**FILE** P. I. Nos. 0006269 & 0002905, DeKalb County **OFFICE** Preconstruction  
CSSTP-0002-00(269) & STP-0002-00(905)  
LaVista Road Sidewalks and Streetscapes **DATE** October 17, 2005

**SUBJECT APPROVED PROJECT CONCEPT REPORT**

LaVista Road Sidewalks and Streetscapes

Project Number: CSSTP-0006-00(269) & STP-0002-00(905)

Lavista Road Streetscape  
Typical Section 1

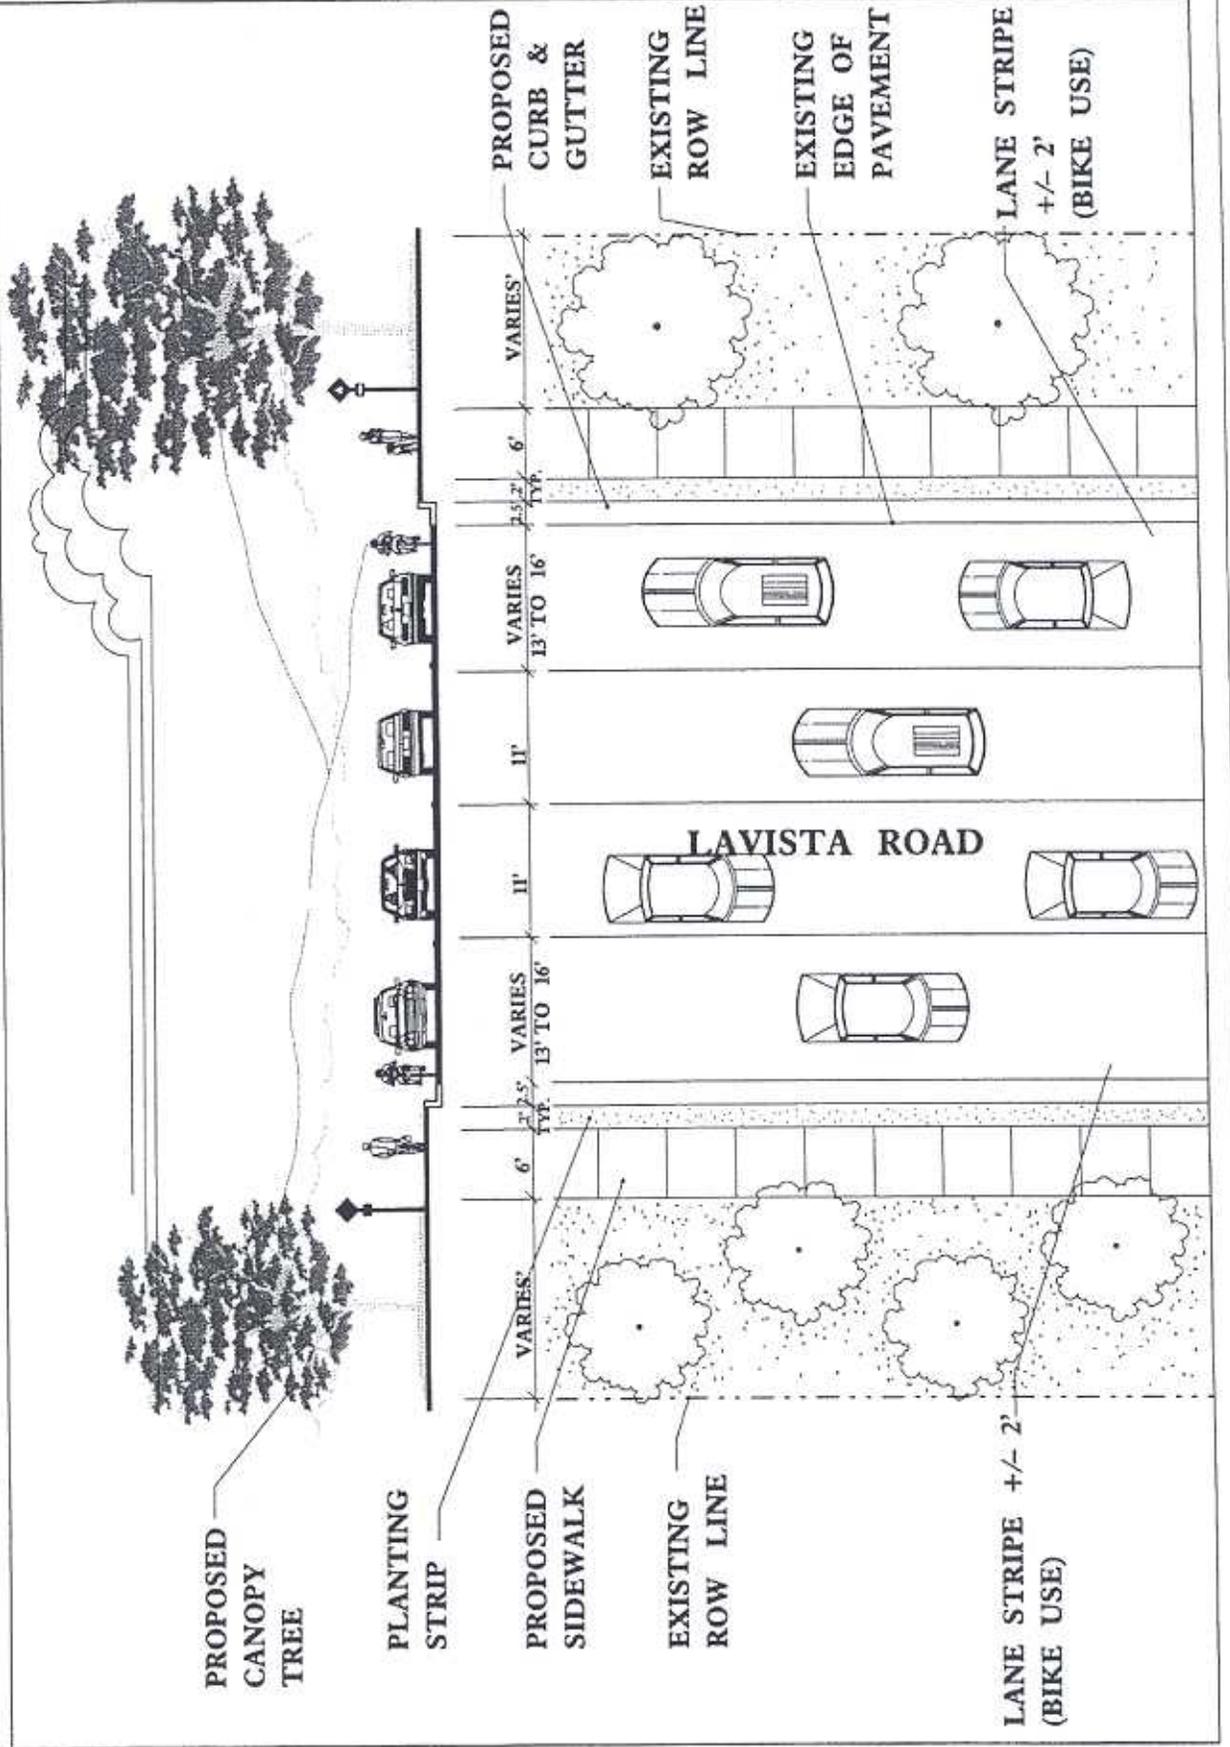
7. In typical section number one (1) (proposed) and others sidewalk placement is proposed with a 2 foot grassed offset. Additional right of way is available to increase this dimension to provide additional offsets for pedestrian safety. Why not increase the separation between the sidewalk and the face of curb/traffic?

7. In typical section number one (1) (proposed) and others sidewalk placement is proposed with a 2 foot grassed offset. Additional right of way is available to increase this dimension to provide additional offsets for pedestrian safety. Why not increase the separation between the sidewalk and the face of curb/traffic? **The buffer strip between the curb and gutter and sidewalk will be increased at locations where additional existing right-of-way is available. However, the width of the buffer strip will be designed in order to maintain consistency and minimize meandering of the sidewalks.**

LaVista Road Streetscape  
Typical Section 2

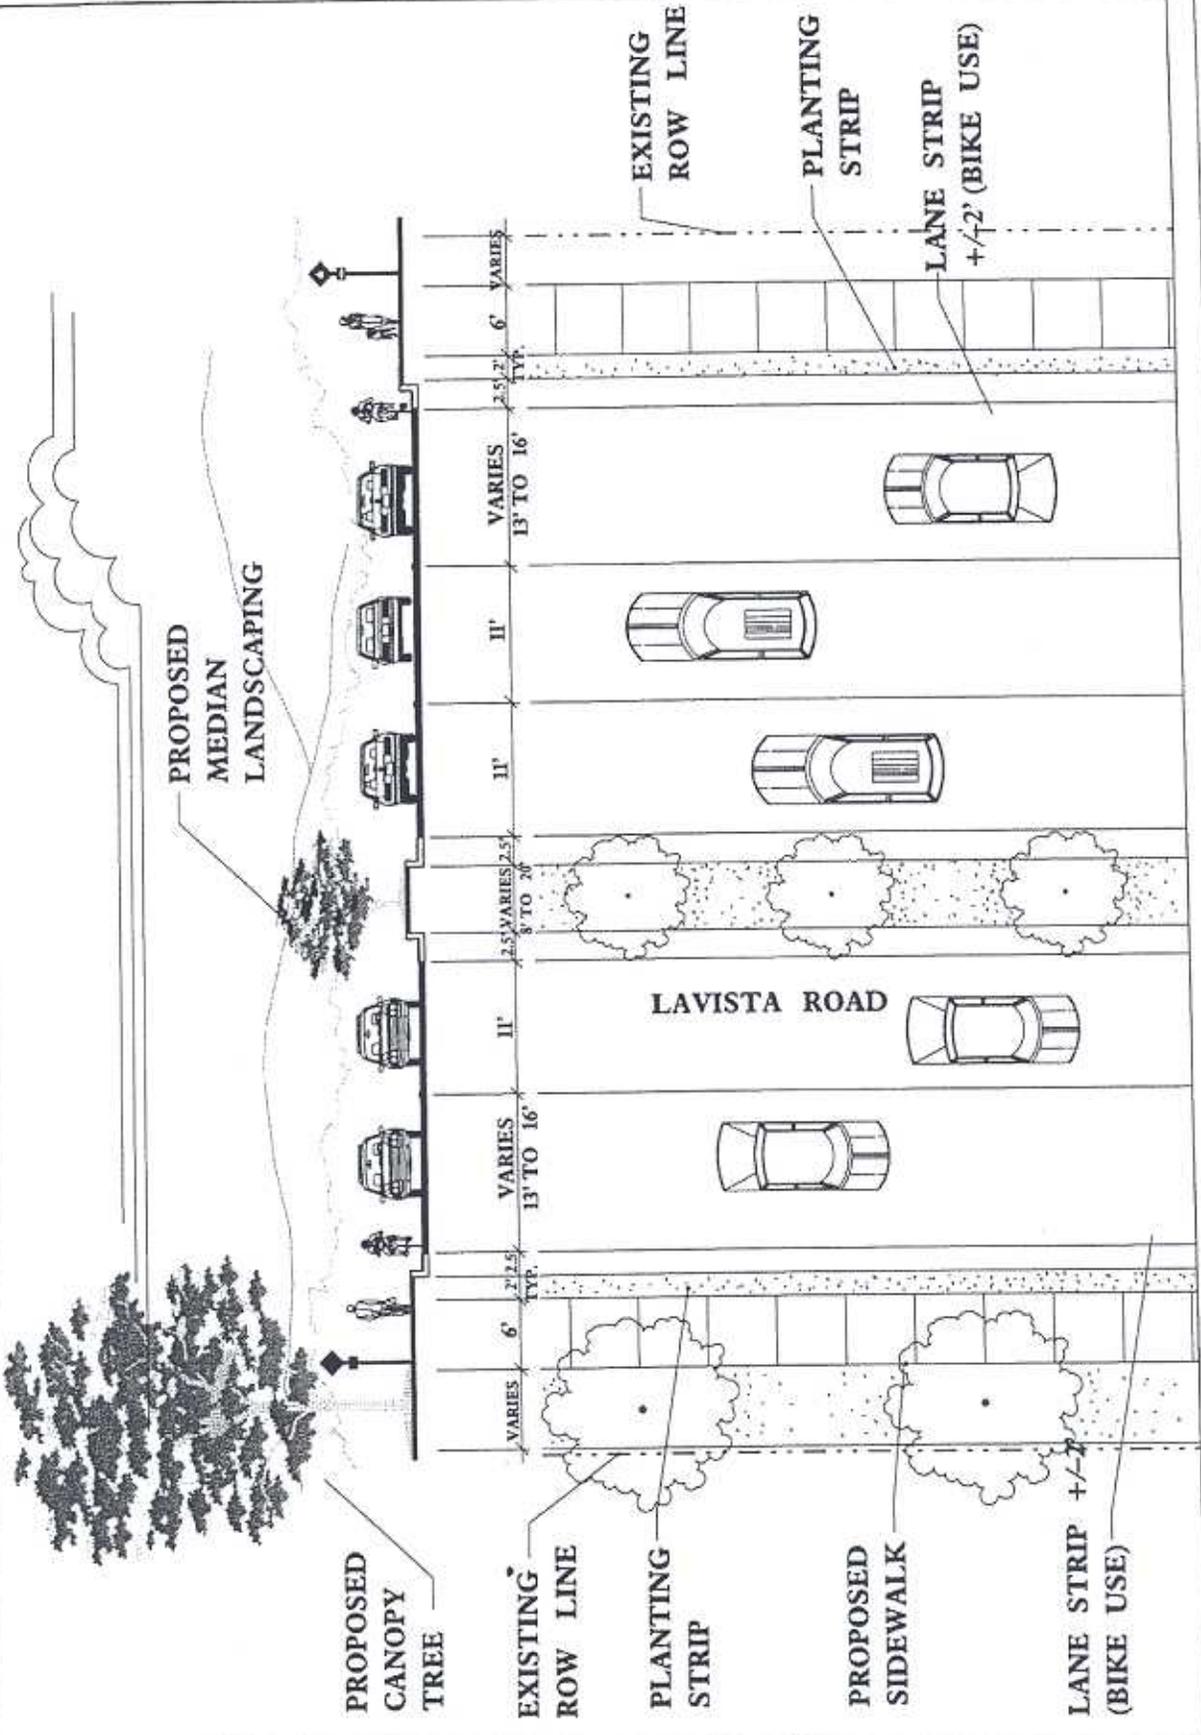
8. On typical section number five (5), a 7.44 foot median is proposed. Is this pavement markings only or is it a raised concrete median? Please clarify.

8. On typical section number five (5), a 7.44 foot median is proposed. Is this pavement markings only or is it a raised concrete median? Please clarify. **The median at this location is flush, with pavement marking only. All typical sections will be revised to clarify proposed intentions.**
